**Addendum No. 1**

RE: Contract # C204949

**Moore County (R-5726)**

NC-211 FROM NC-73 TO WEST OF SR-1241 (HOLLY GROVE SCHOOL RD).

PROJECT REFERENCE NO.	SHEET NO.
R-5726	2D-2
RW SHEET NO.	
HYDRAULICS ENGINEER

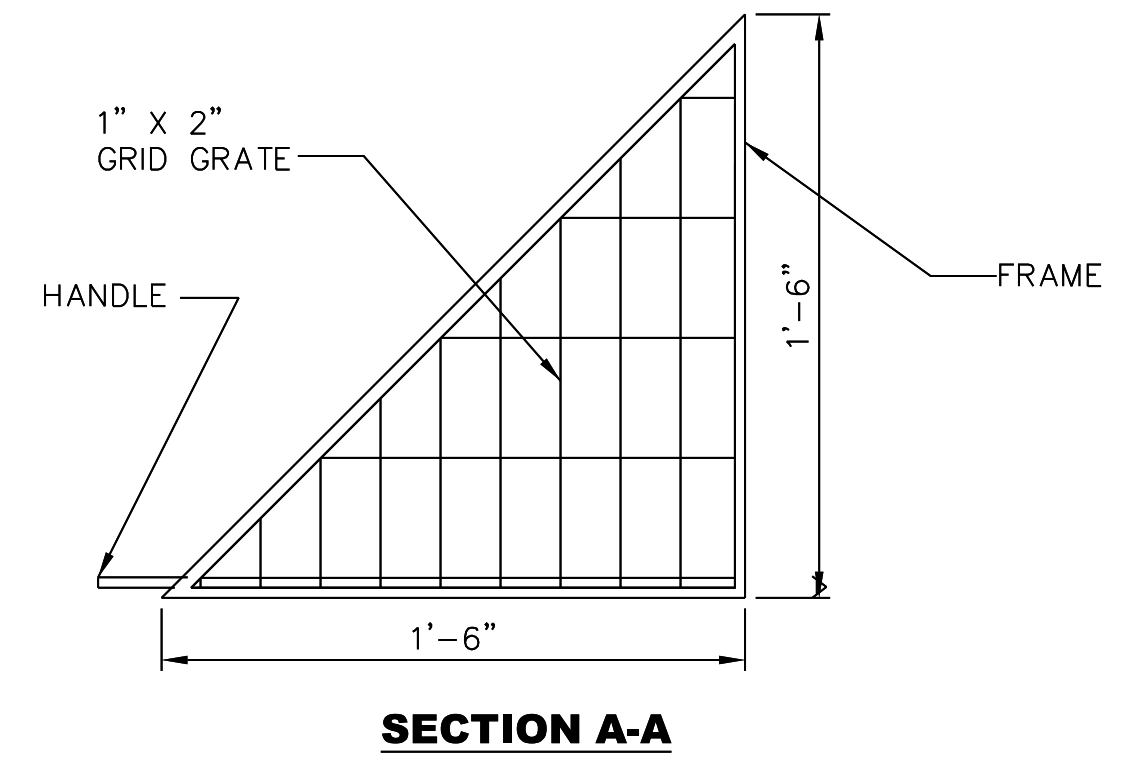
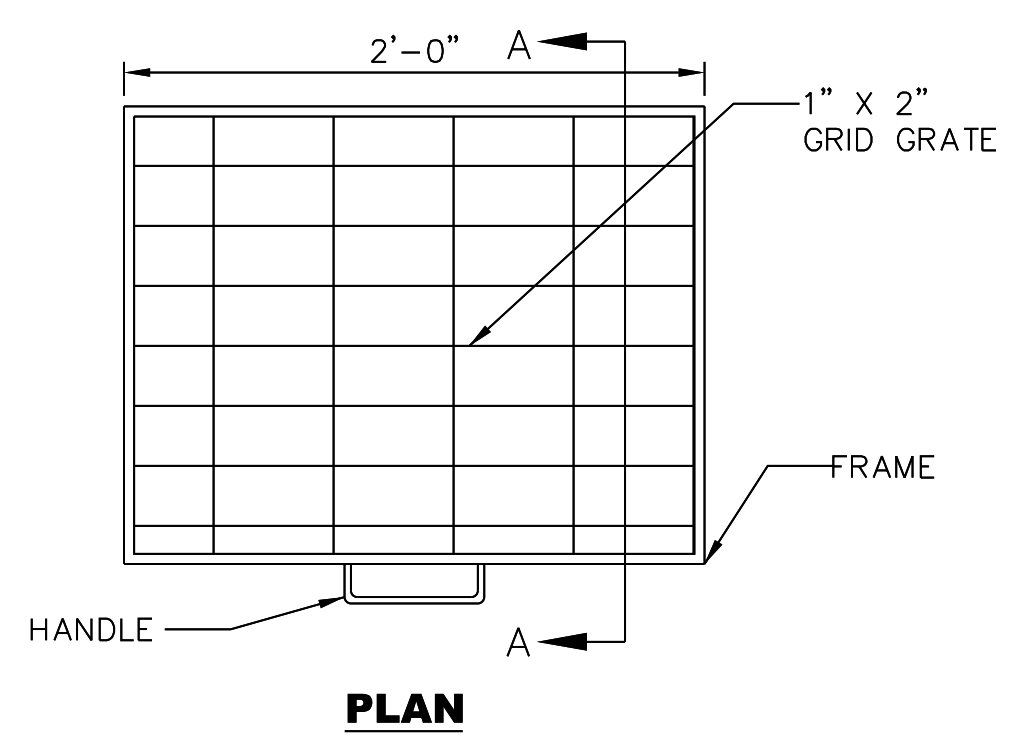
Sheet No.	Revision
2D-2	Note added: "Trash Rack is incidental to the Drainage Structure"
2D-3	Note added: "Trash Rack is incidental to the Drainage Structure"

\*\*TRASH RACK IS INCIDENTAL TO THE DRAINAGE STRUCTURE\*\*
